Fax Number 654 392 Job No W 8165
Job Name 249 Madras st Structural report
To Robin Schulz of Schulz Knight
From John Hare
Time 10-40 Date 31/1/90
Re: _____

RE: 249 MADRAS STREET

STRUCTURAL REPORT

**OFFICE BUILDING
249 MADRAS STREET**

SKETCH 3508/SK1

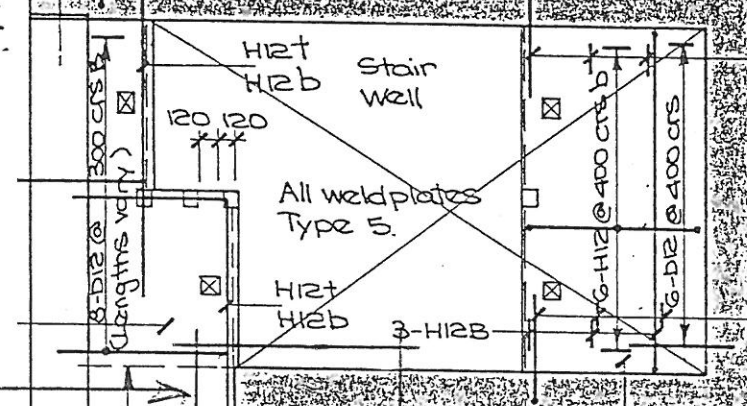
Further to our discussions by telephone this morning, we confirm that the scope of the possible non-compliance referred to in your report on the building is the connections between the walls on gridlines D and D/E, as shown on the attached sketch SK1 from levels 2 to 6 inclusive (Level 1 being the ground floor carpark).

The proposed remedial work, if required, would consist of a total of two ties per floor, tying the walls to the floor diaphragm.

The agreed maximum tie load is 300 kN per tie. We understand that this load would be reduced on lower floors in accordance with the "Parts and Portions" section of NZS 4203:1984.

Line D Wall Tie to slab here

Line D/E Wall Tie to slab here.

PAGE Sk-01
 DATE 31/1/20.

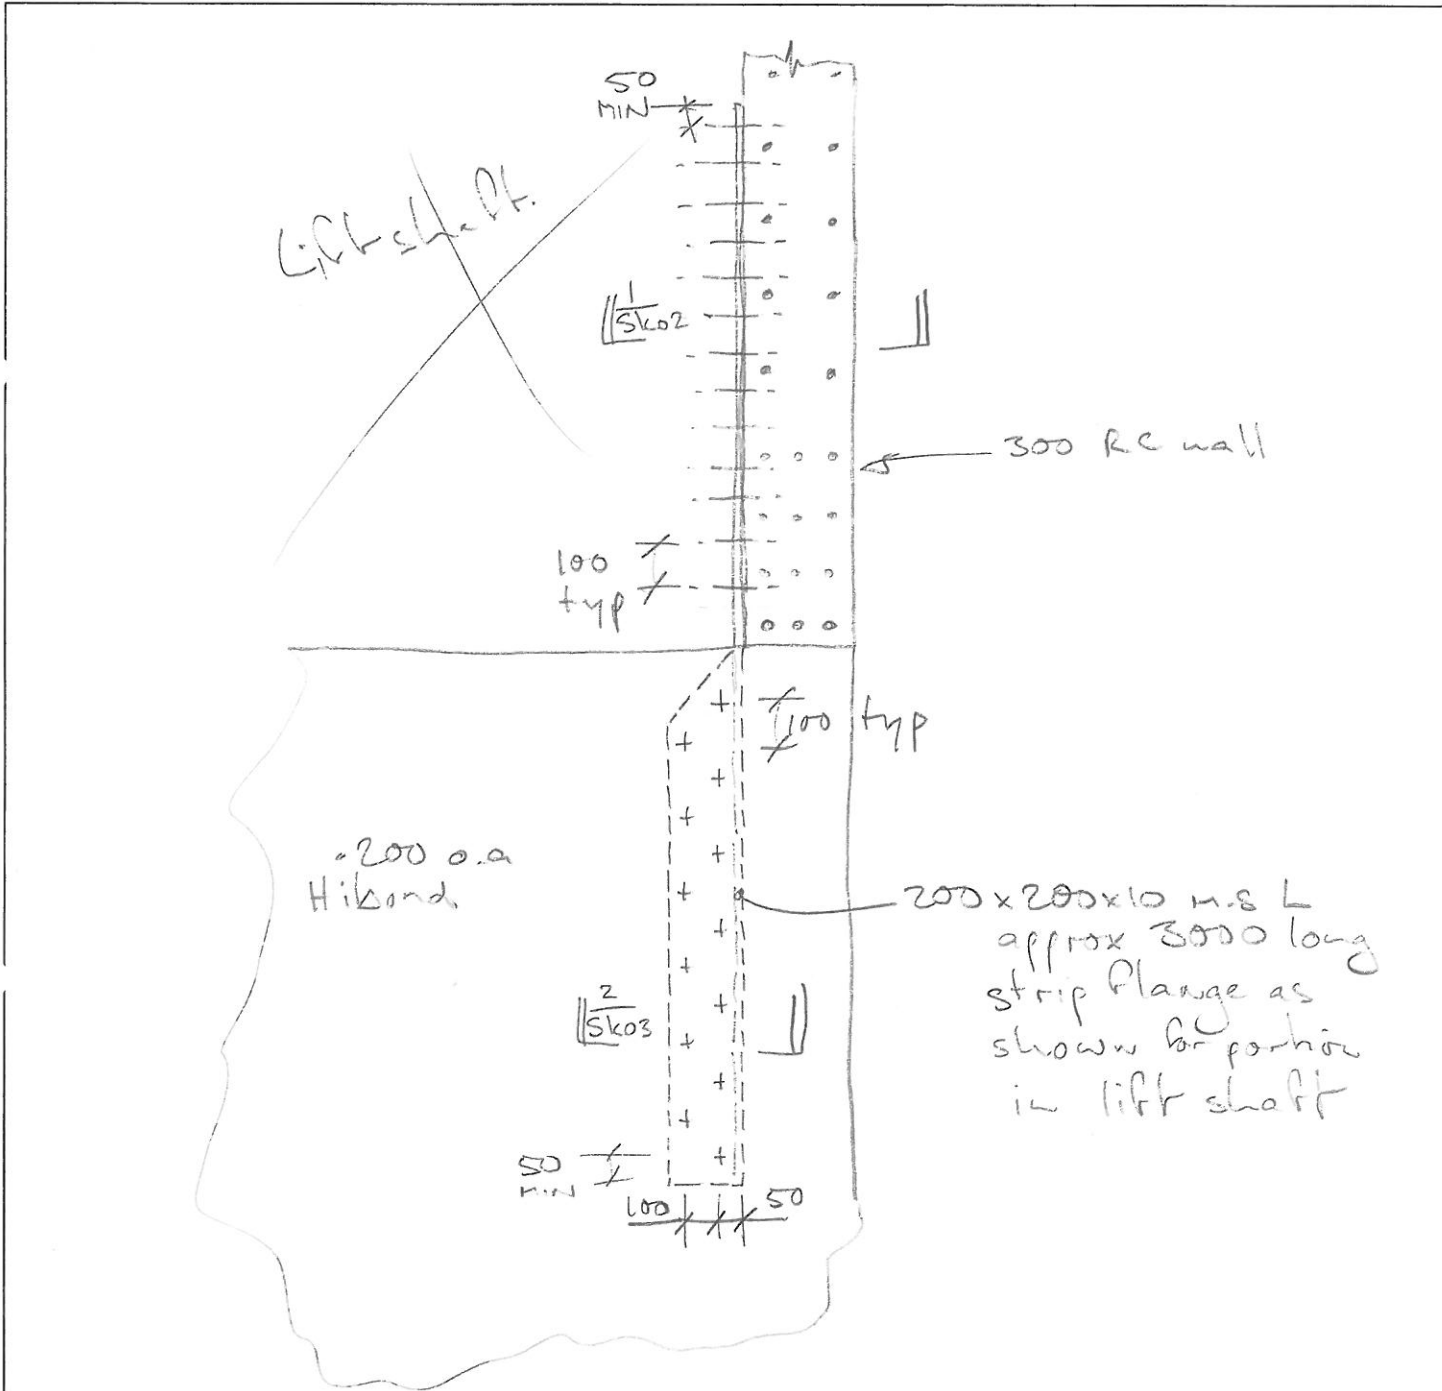
Remedial Works

Steel angle required.

2 per level at 5 levels.

- Require similar detail but handed at other side of lift shaft.
- Detail typical to levels 1 to 5.
- Reinstate all finishes when work completed eg ceilings, carpet.

Sk-02

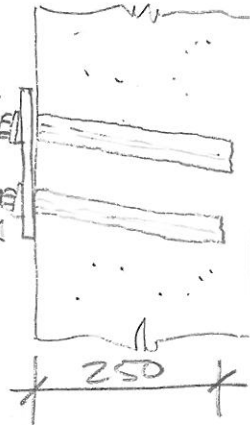
200x200x10 u-sL
with flange removed
over part
of 13 or 14 studs

D12 threaded
bars with tapered
washers.

- Mark out & drill holes before cutting or drilling steel. Locate steel in wall prior to drilling holes.
- Holes in wall to be ϕ drilled using percussive rotary drill. Epoxy bars using Expocrete 'S' or equivalent.

PAGE Sk-03

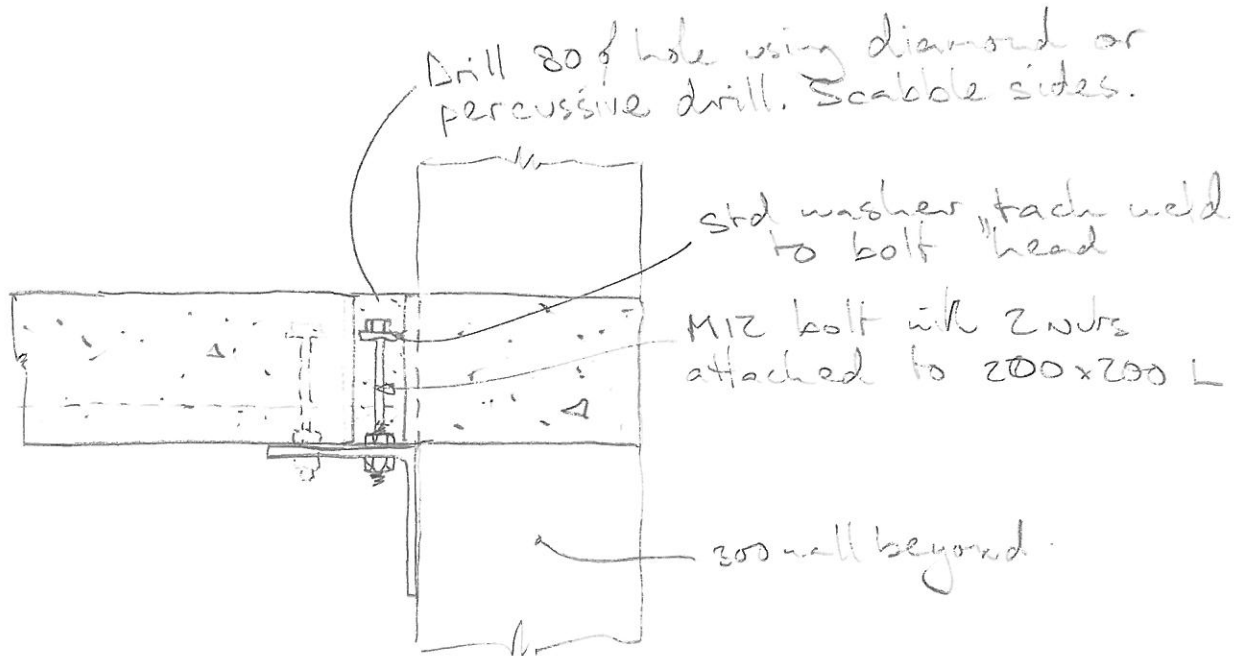
- Prior to drilling holes locate M12-200 bars top steel in slab. Confirm detail with engineer if any clash occurs.
- Mark out and drill holes through slab prior to cutting steel.
- After placing bolts, temporarily fix angle to underside of slab, and seal around gaps between Hibond ribs.
- Grout gap using Sika 212 or similar
